CITY OF HOBART

## **Special City Planning Committee Meeting**

#### **3.1.1 14 Goulburn Street, Hobart - Signage and Fencing - PLN-20-717 File Ref: F21/14529**

### **14 Goulburn Street, Hobart - Signage and Fencing - PLN-20-717**

1 SITE PLAN 1:200

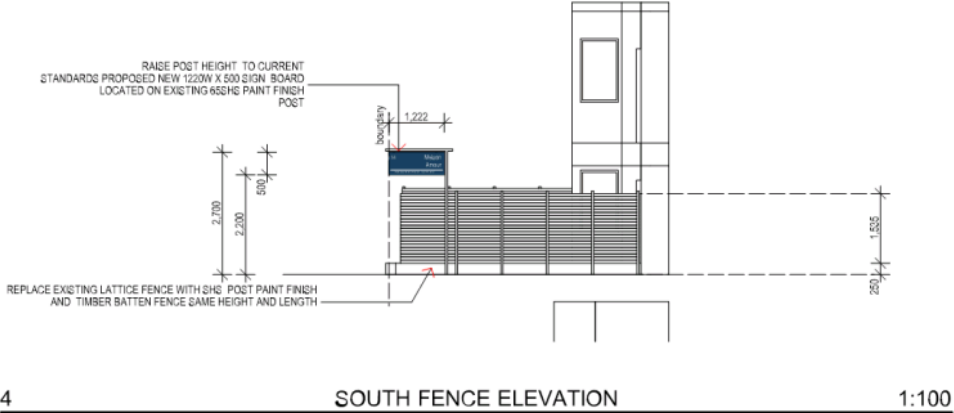
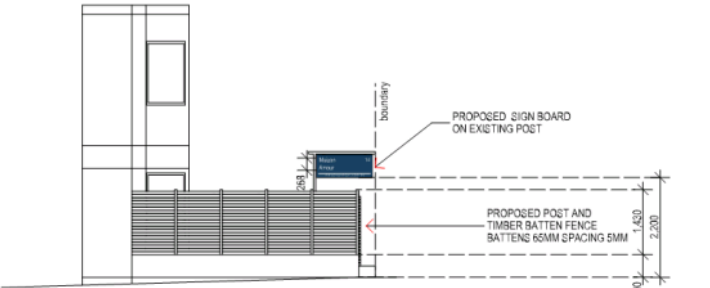
- The construction of a new pole sign on the south western boundary. Whilst there is inconsistency within the drawings, the applicant has confirmed that the sign does not extend beyond the front boundary, and as such the 'north fence elevation' is taken to show the correct location of the sign. The sign is 1.22m wide, 0.5m high, and has a maximum height of 2.7m above the natural ground level, with a clearance of 2.2m beneath it.

- The construction of a new side boundary fence on the south western boundary between the road and the building. The fence is constructed on a newly raised garden bed, and has a maximum height of 1.79m above the natural ground level.

- The construction of a new fence 1.25m from the north eastern side boundary between the road and the building. The fence has a maximum height of 1.93m above the natural ground level.

FIGURE 1: lengthway comparison of a car park that meets the Australian Standards and the proposed car park.

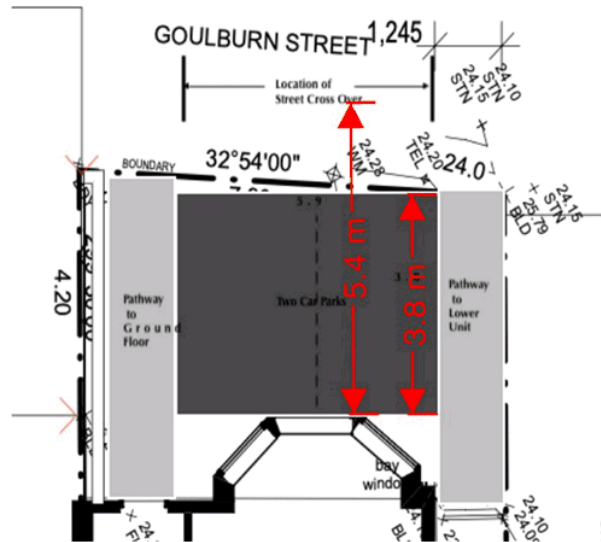
Therefore **DE will not accept car park spaces shown on plans provided and will recommending refusal..**

The two proposed parking spaces are 1.6 m shorter than the required minimum length and will clearly place any B85 vehicle outside the property boundary and into the road reservation (SEE FIGURE 1).

The car park plans provided 15/12/2021 show a width of 5.9 m wide x 3.8 m long. Minimum size requirements for a standard 90 degree parking space, user class 1 (general/all day parking) according to AS 2890.1 is 2.4 m wide x 5.4 m long (SEE FIGURE 2). Figure 3 shows and aerial view of the vehicles extending from the property boundary.

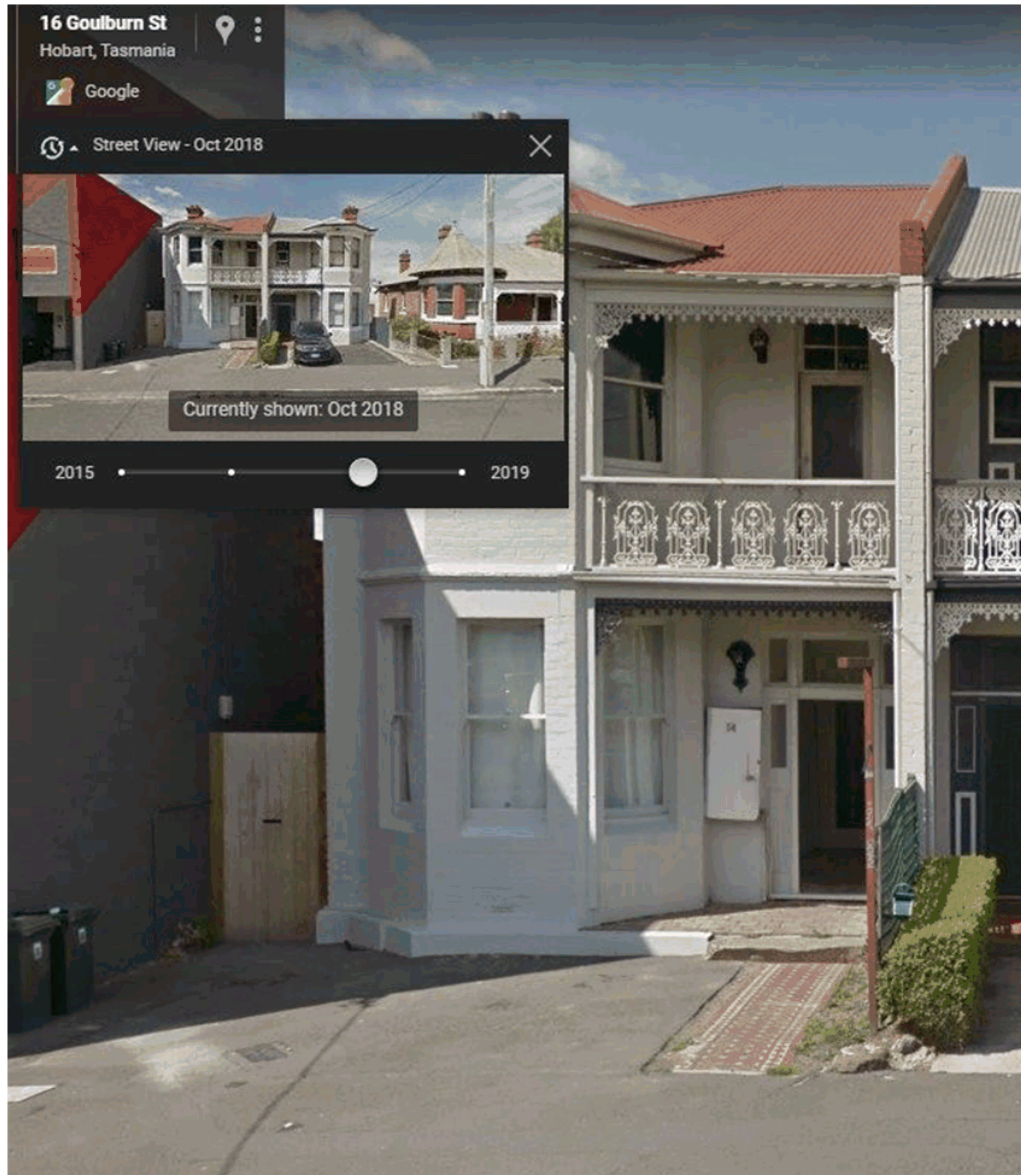
The applicant is 'proposing' the demolition of 19th century sandstone and tessellated tile landscape elements. Tessellated tiles with edging is typical of 19th century houses and gardens. The pathway, evident in photographs attached to this report, show a typical late Victorian design, featuring a diagonal two-tone design motif. The pathway is original to the house and demonstrates the extent of the former garden and is considered to be significant. The applicant has not provided, as part of this application, any environmental, social, economic or safety reasons of greater values to the community than the historic heritage values of the place (a). A prudent and feasible alternative would be to refurbish the tessellated tile pathway (c) and the pathway was not documented prior to demolition (d). The proposed demolition of
